February 6, 2017

Please accept our Round 1 review comments. All comments have been responded to in writing referencing each by Department and number. Since there was no revision to the plans, until they are submitted for the building permits, we have not included plans.

## Addressing: Interoffice Memorandum

## Demising Plan

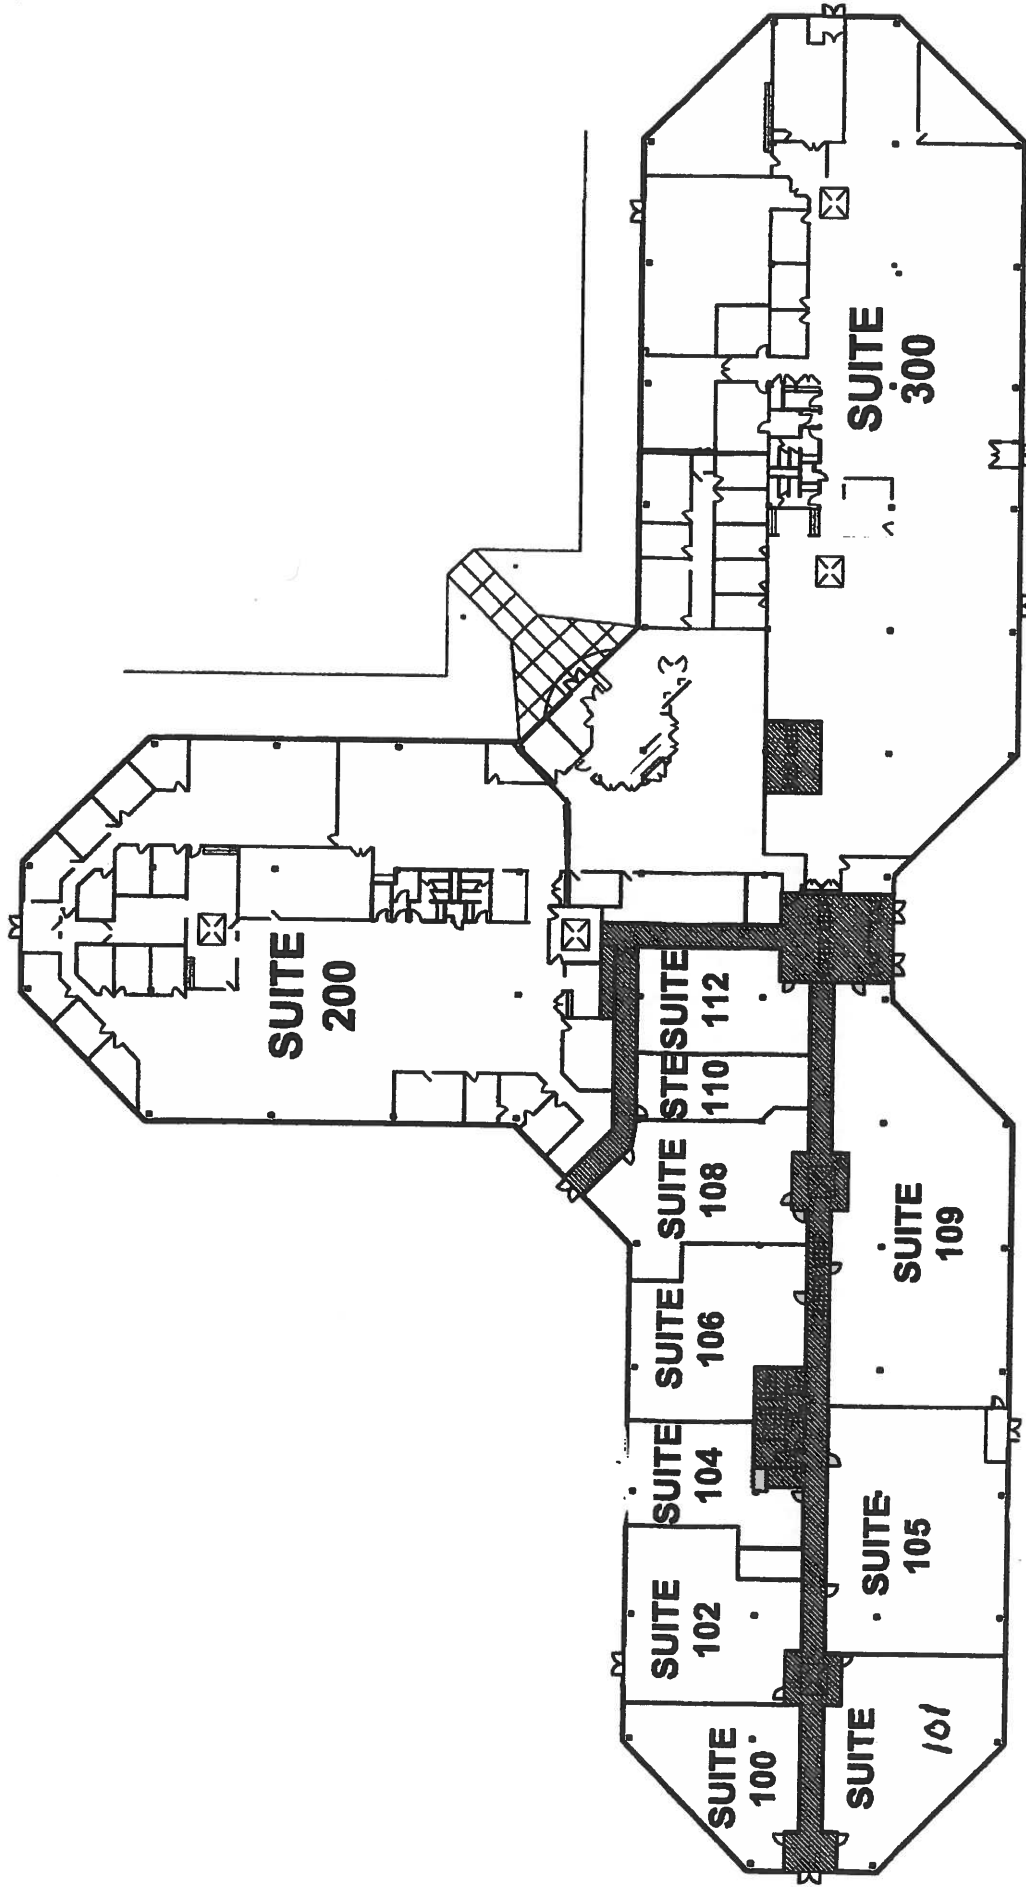
a. The "Rent roll" sheet did not match the "Demising Plan" sheet illustrating where the tenant spaces are located. Please provide an accurate exhibit illustrating where the tenant spaces are located within the building.

- o **See above revised RENT ROLL TABLE that matches the attached revised DEMISING PLAN.**
